## Product Change Notification / CENO-13NWUA734

CCB 6079 Initial Notice: Qualification of MTAI as an additional assembly site for selected AT24C512C-SSHxx, AT24CM01-SSHxx and AT24CM02-SSHxx device families available in 8L SOIC (3.90mm(.150in)) package.

**CCB 6079**  
**Pre and Post Change Summary**  
**PCN #: CENO-13NWUA734**

# LEAD FRAME COMPARISON

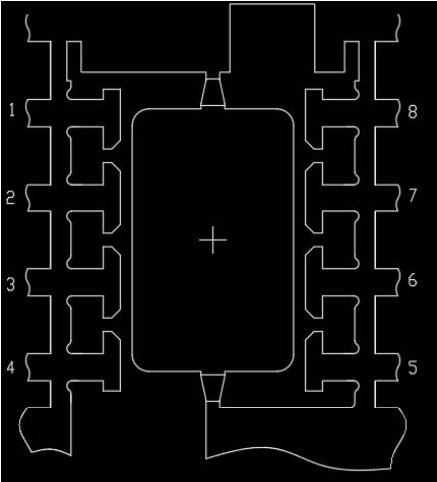
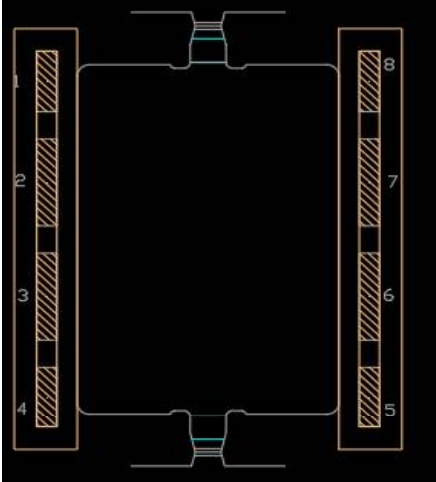
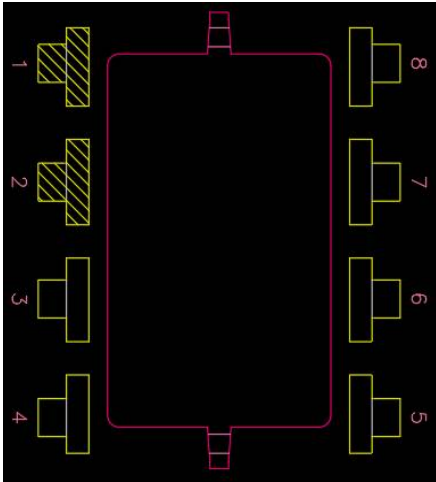
**Description of Change:**Qualification of MTAI as an additional assembly site for selected AT24C512C-SSHxx, AT24CM01-SSHxx and AT24CM02-SSHxx device families available in 8L SOIC (3.90mm(.150in)) package.

Pre Change		Post Change		
<b>Assembly Site</b>	Amkor Technology Philippine (P1/P2), INC.  (ANAP)	ATX Semiconductor (Shanghai)Co. Ltd (ASSH)	Amkor Technology Philippine (P1/P2), INC.  (ANAP)	ATX Semiconductor (Shanghai)Co. Ltd (ASSH)	Microchip Technology Thailand (HQ) / MTAI
Wire Material	PdCu	CuPdAu	PdCu	CuPdAu	CuPdAu
Die Attach Material	8290	EN-4900G	8290	EN-4900G	8008MD
Molding Compound Material	G700A	CEL9240HF10AK	G700A	CEL9240HF10AK	G600V
Lead-Frame Material	C194	C194	C194	C194	CDA194
Lead-Frame Paddle Size	95 x 155 mils	102 x 153 mils	95 x 155 mils	102 x 153 mils	95 x 158 mils
	See Pre and Post Change Comparison				
Lead Plating	NiPdAu	Matte tin	NiPdAu	Matte tin	Matte tin
DAP Surface Prep	PPF	Bare Cu	PPF	Bare Cu	Bare Cu

<i>Note: Not to scale</i>		<i>Note: Not to scale</i>		<i>Note: Not to scale</i>	
Lead frame Material	C194	Lead frame Material	C194	Lead frame Material	C194
Lead-Frame Paddle Size	95 x 155 mils	Lead-Frame Paddle Size	102 x 153 mils	Lead-Frame Paddle Size	95 x 158 mils
Lead Plating	NiPdAu	Lead Plating	Matte tin	Lead Plating	Matte tin
Wire Material	PdCu	Wire Material	CuPdAu	Wire Material	CuPdAu
